DOCUMENTATION CHANGE REQUEST

Doc. No. (6) Status (7) Title (8)
 3401/064 Issued, rev. C Accessories for circular connectors 3401/008.

Paragraph(s) and page(s) affected (9)
 Figure 2(e) - CABLE CLAMP SLEEVE, page 9.
PROPOSED WORDING OF CHANGE

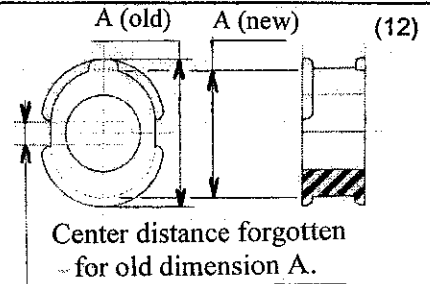
Corrections of dimensions
 (according to figure and
 table page 2).

- 1). Dimension A doesn't reflect DEUTSCH drawings reference 006-0005-** (for every sizes, the center distance of the oval radius shown on the following picture has been forgotten. This dimension isn't functional. We propose to indicate the new A dimension shown on the figure page 2, with the tolerance $\pm 0,30$).
- 2). Internal diameter $\varnothing C$ doesn't reflect DEUTSCH drawings (for sizes 12, 19, 27 & 61, a modification dated Sept. 1989 in order to meet MS 3124 requirements has not been introduced into the specification.

Page [2] of [2]

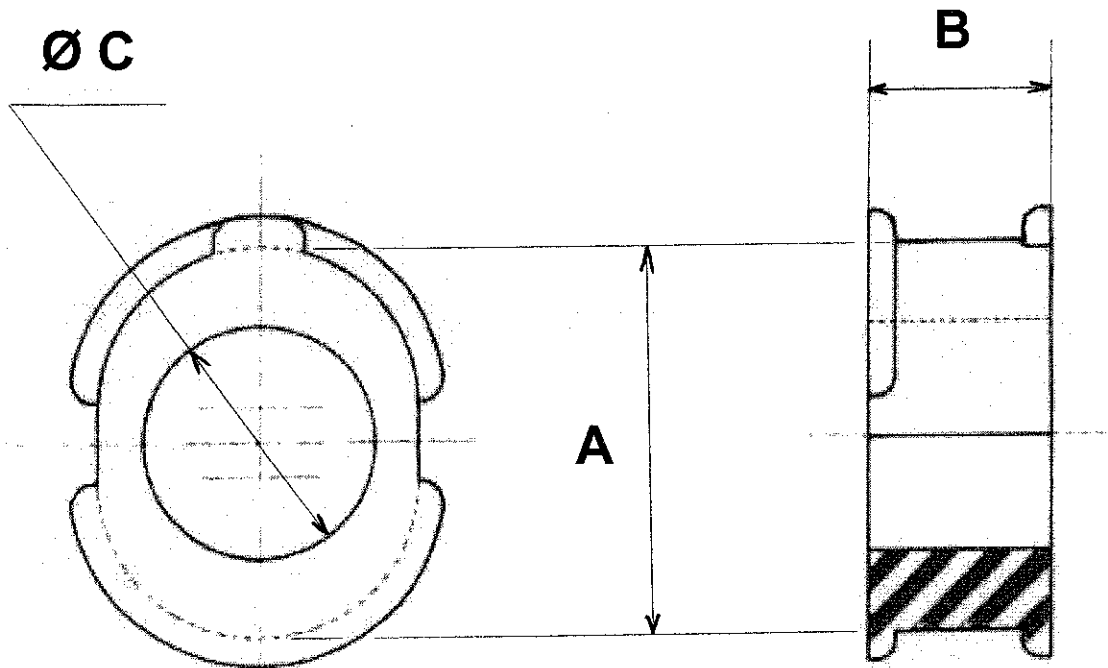
La visualisation de l'entraxe (oublié dans le calcul de la cote A) a été retirée de la figure page 2 (qui peut dorénavant être intégrée directement dans la spécification) et se situe plus logiquement au § justificatif page 1.

| Variant | Used with Shell size | Dimensions (mm) | | |
| | | A (± 0.30) | B (± 0.10) | Ø C (+ 0.20 - 0) |
| 29 | 03 | 6.20 | 10.00 | 3.00 |
| 30 | 07 | 12.60 | 10.00 | 7.90 |
| 31 | 12 | 15.90 | 10.00 | 9.00 |
| 32 | 19 | 19.30 | 10.00 | 12.10 |
| 33 | 27 | 21.90 | 10.00 | 15.30 |
| 34 | 37 | 25.60 | 10.00 | 15.90 |
| 35 | 61 | 33.30 | 10.00 | 19.70 |
